TRI-PARTY AGREEMENT

Change Notice Number TPA-CN- 1112	TPA CHANGE NOTICE FORM	Date: December 27, 2022
Document Number, Title, and Revision: DOE/RL-2017-13-ADD1, Groundwater Monitoring Sampling and Analysis Plan for the 100-HR-3 Groundwater Operable Unit, Rev. 0		Date Document Last Issued: July 27, 2021
Approved Change Notices Against this Document: TPA-CN-1109		
Originator: S. J. Bendaña		Phone: 509-373-6734
Description of Change:		
<p>Table B-1 is amended to add four RUM aquifer extraction wells and two monitoring wells to the sampling and analysis schedule. The waste management plan for handling the drilling-derived wastes is updated by adding the six wells to Table B-1. Additionally, there are six extraction wells that have been realigned to injection wells and are removed from the groundwater sampling schedule. Five extraction wells have been converted to monitoring wells. Two monitoring wells that are added to the automated water level network (AWLN) and one well that is removed from the AWLN. One monitoring well needs to be sampled specifically during high river stage. The sampling frequencies for five wells near known continuing sources of contamination in 100-HR-3 were chan

Figure B-1. Available Monitoring Locations as of August 31, 2022

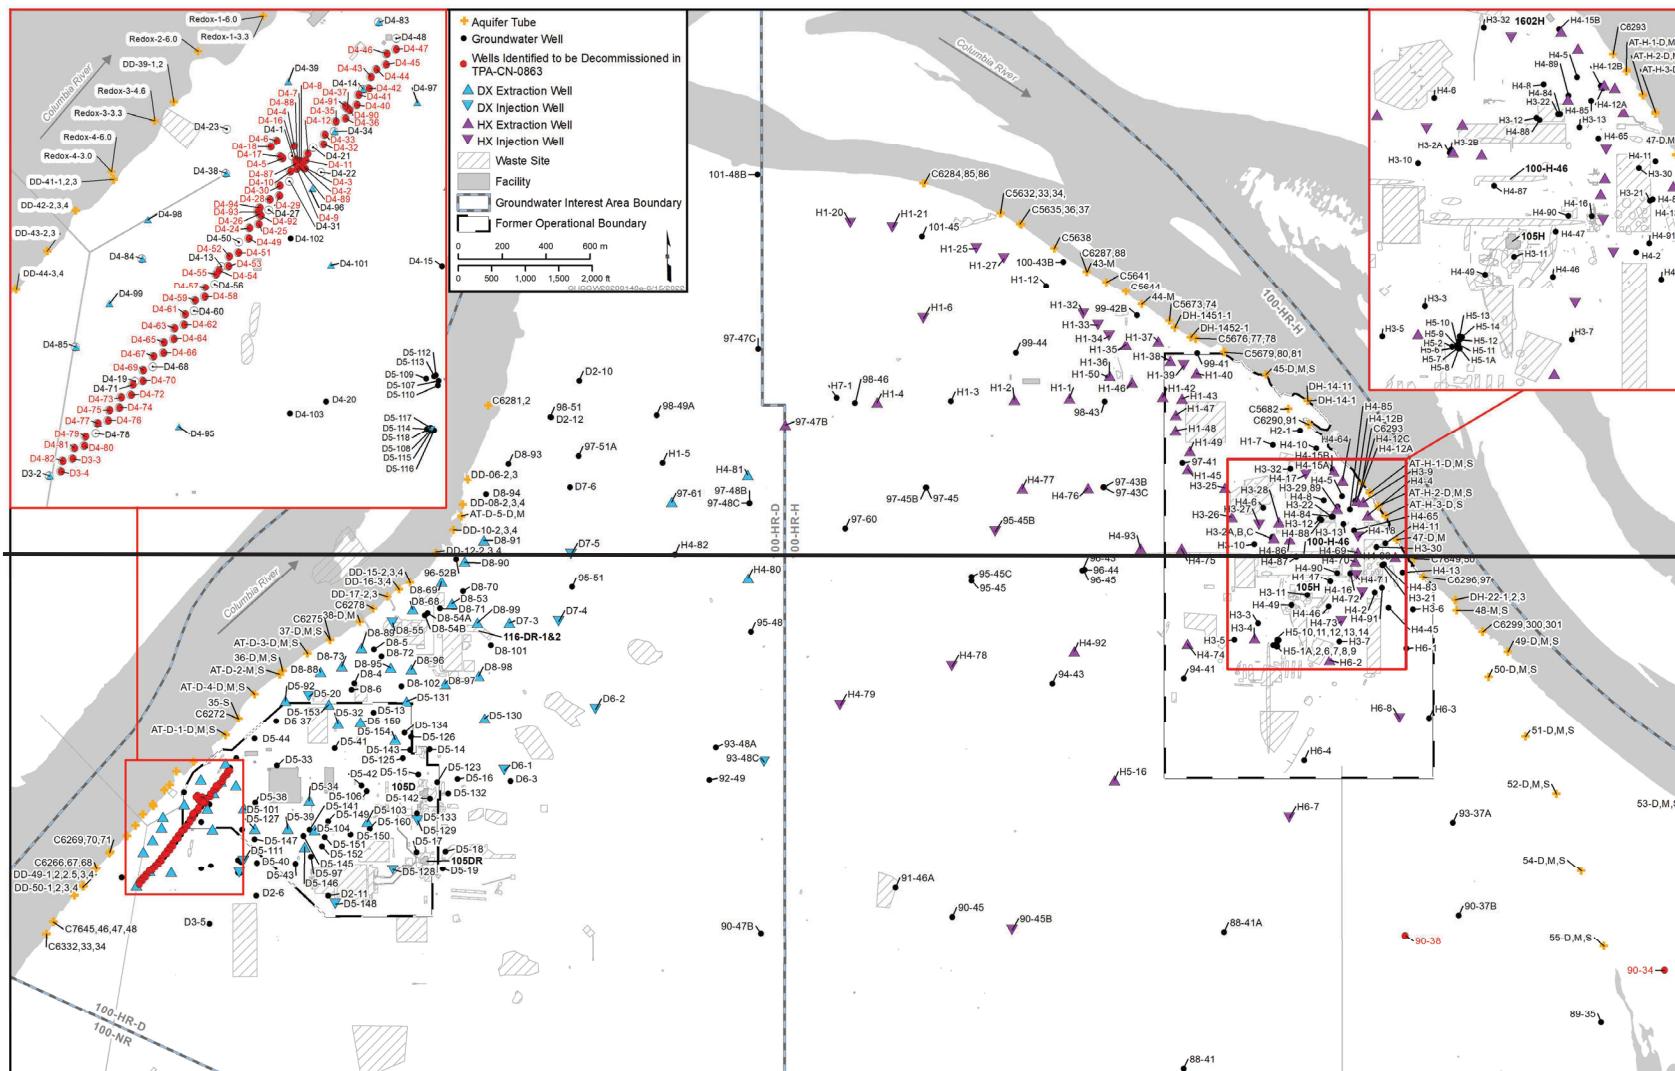
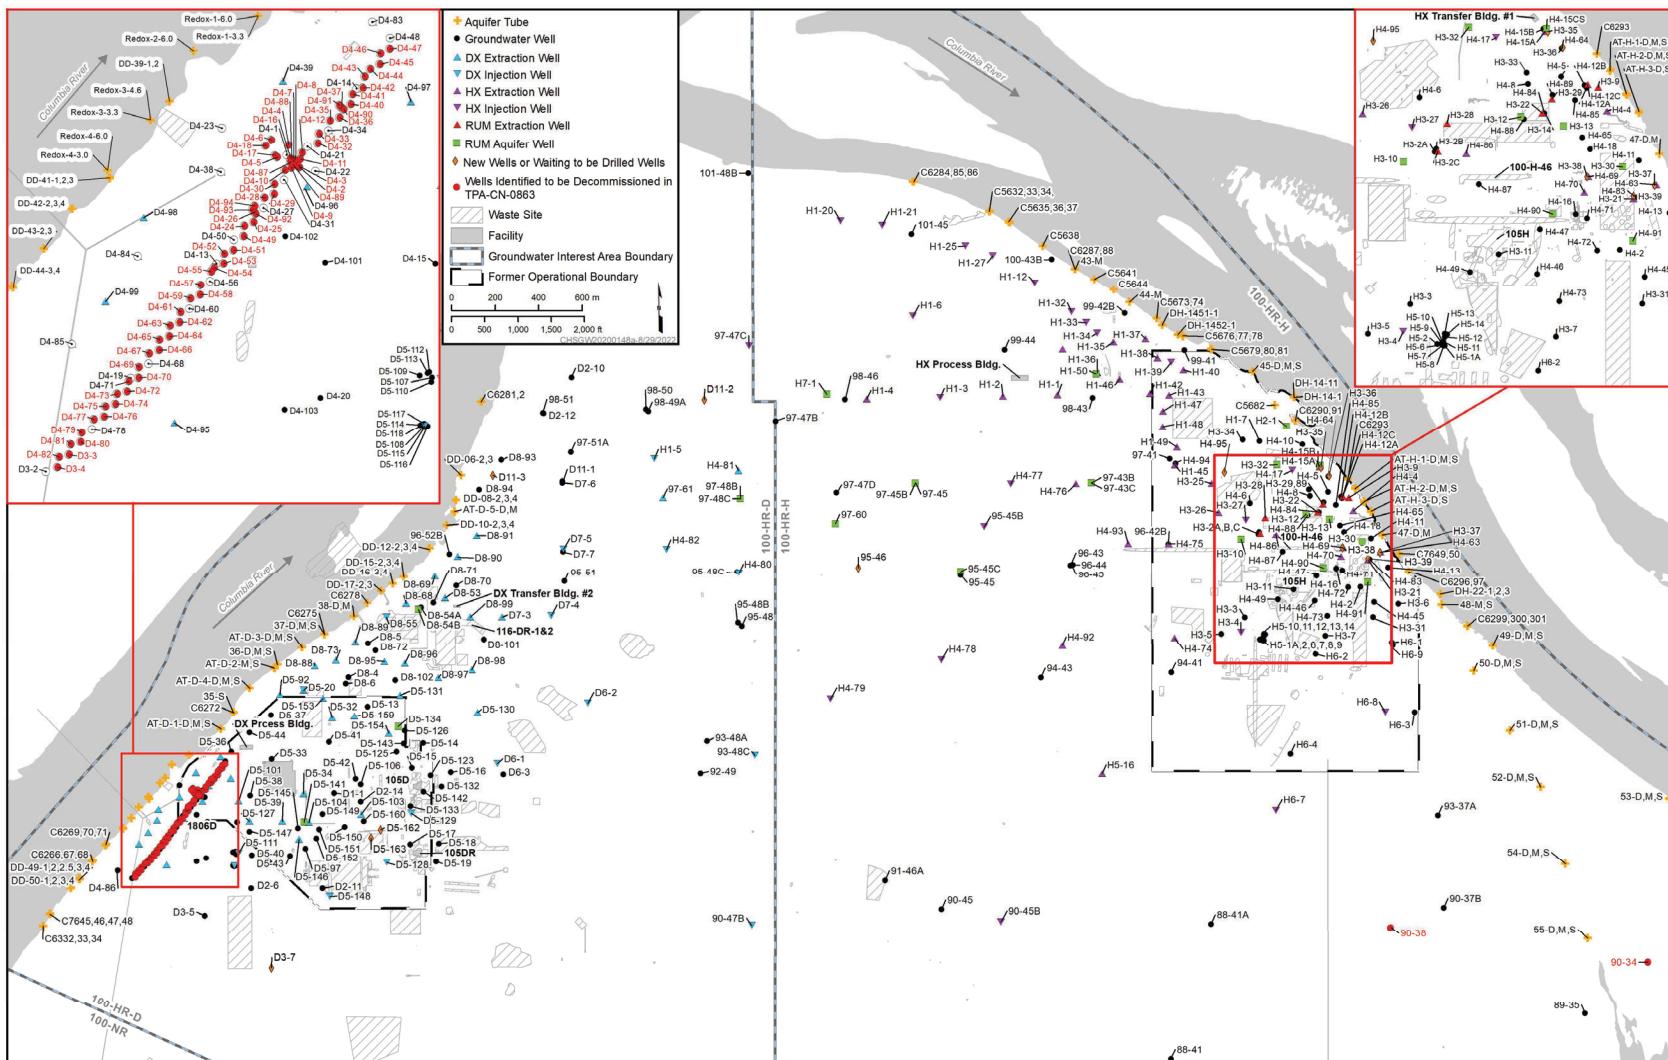
- 199-H4-89 (Hexavalent Chromium [Cr(VI)], Nitrate and Uranium)
- Updated Figure B-1. 100-HR-3 Well Network as of August 2022.
- Added an "Change History for DOE/RL-2017-13-ADD1, Groundwater Monitoring Sampling and Analysis Plan for the 100-HR-3 Groundwater Operable Unit" Table. Added an additional page "xi".

<p>(4) <u>Updated Table B-1 to reflect addition to the HR-3 automated water level network (AWLN) for the following wells</u> • <u>199-H3-2A</u> • <u>199-H4-88</u></p> <p>(5) <u>Updated Table B-1 to reflect deletion to the HR-3 automated water level network (AWLN) for the following wells</u> • <u>199-D4-13</u></p> <p>(6) <u>Updated Table B-1 to reflect unconfined monitoring well that needs to be sampled during high river stage</u> • <u>199-H1-7</u></p> <p>(7) <u>Updated sampling frequencies from annually to quarterly for the following wells in Table B-1</u> • <u>199-H3-21 (Hexavalent Chromium)</u> • <u>199-H4-83 (Hexavalent Chromium)</u> • <u>199-H4-84 (Hexavalent Chromium, Nitrate, and Uranium)</u> • <u>199-H4-88 (Hexavalent Chromium, Nitrate, and Uranium)</u> • <u>199-H4-89 (Hexavalent Chromium, Nitrate, and Uranium)</u></p> <p>(8) <u>Updated Figure B-1. 100-HR-3 Well Network</u></p>	
---	--
